Advisory Board on Radiation and Worker Health
National Institute for Occupational Safety and Health

**Review of ORAUT-RPRT-0092, Revision 00, “Evaluation of
Bioassay Data for Subcontracted Construction Trade
Workers at the Savannah River Site”**

**Contract No. 75D30119C04183
Document No. SCA-TR-2019-SEC005, Revision 0**

November 12, 2019

Figure 3. Number of years elapsed between end of job plan and internal monitoring result

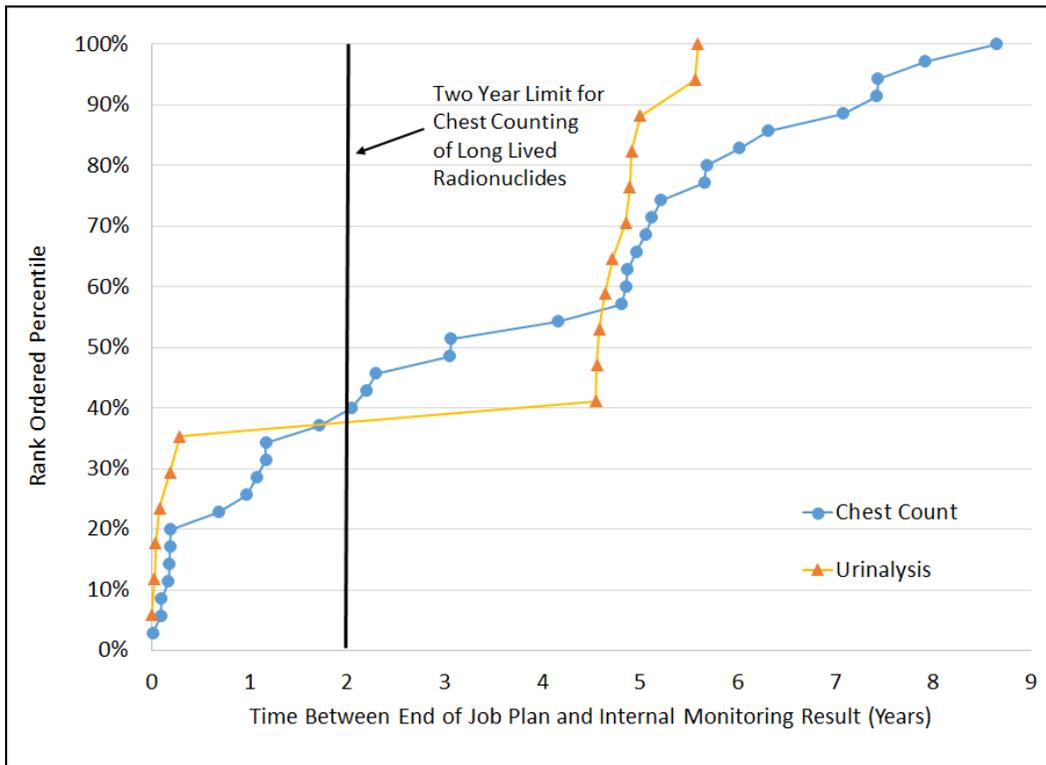
Although nearly two-thirds of the job plans had at least one worker with internal monitoring for americium, this reflects just 20 percent of the total identified americium workers. As noted in table 4, a large portion of the workers monitored via chest count were removed due to the chest count occurring more than 2 years after the end of the job plan. This is in accordance with ORAUT-OTIB-0060, revision 02 (NIOSH, 2018b), and restated in RPRT-0092, which notes that long-lived nuclides monitored via chest count must be treated as a short-lived nuclide for which periods longer than 2 years are considered unmonitored (see section 5 of this report for the pertinent excerpt from RPRT-0092 quoting ORAUT-OTIB-0060). Figure 3 plots the time elapsed between the identified internal monitoring results and the end of the job plan.

Although long-lived urinalysis results for americium are considered valid for the purposes of internal monitoring, it is clear that the majority of urinalysis results were not associated with the actual job plan, as they were taken more than 4 years after the end of the work. Furthermore, the 17 identified urinalysis results shown in table 4 were taken from just three workers. Eleven of the 17 results were taken from [REDACTED] in 1991 and was sampled subsequent to [REDACTED] (i.e., neither the sample nor the reason for the sample occurred in the period of interest). The remaining two workers were involved in separate incidents [REDACTED].

Figure 4. Number of RWPs per SRS area per year (1990–1998)

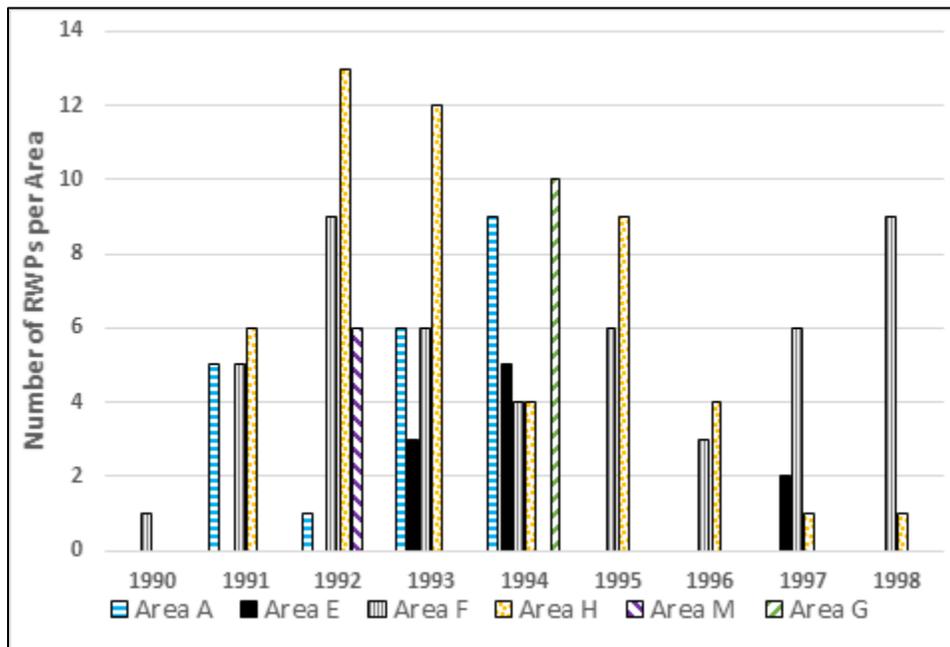
Figure 4 indicates that, of the 146 RWPs analyzed, the main concentration of the RWPs was during the period 1992–1994, with Areas F and H containing the largest fraction of the total number of RWPs.

There was only one RWP with one unmonitored subCTW listed for 1990. This does not appear to warrant bundling 1990 with 1991 and treating it as part of the period when additional data became available. The year 1990, with one RWP, is not much better than 1989 (no job plans identified) or any other previous year. Although there were corporate changes taking place at that time, there was a lag time in policy implementation; therefore, it would be more appropriate that the time intervals should be broken up into 1972–1990 and 1991–1998, so that 1990 is considered in the era with very limited data.

Figure A1. Fraction of NOCTS in vitro bioassays from areas at SRS (1972–1990)

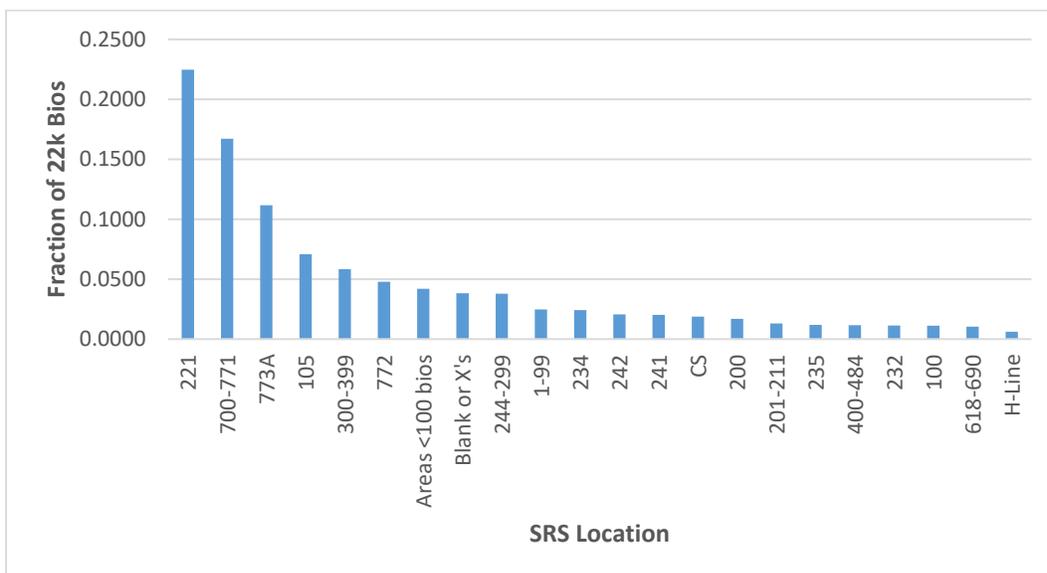
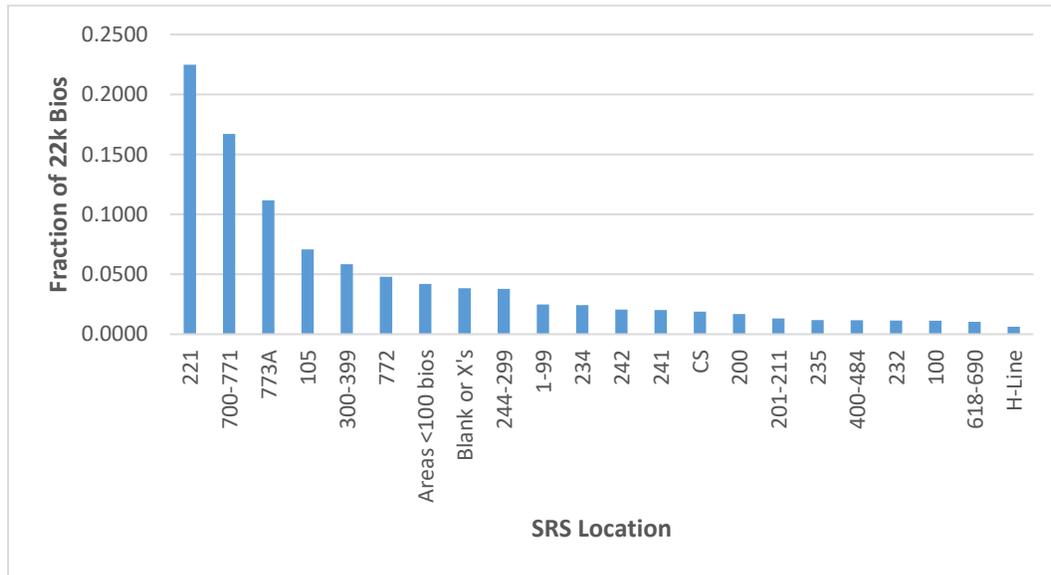
This analysis indicates that the 1972–1990 NOCTS coworker bioassay data used in OTIB-0081 were not concentrated in only Area A, as the RPRT-0092 1972–1989 job plan and SWP data were.
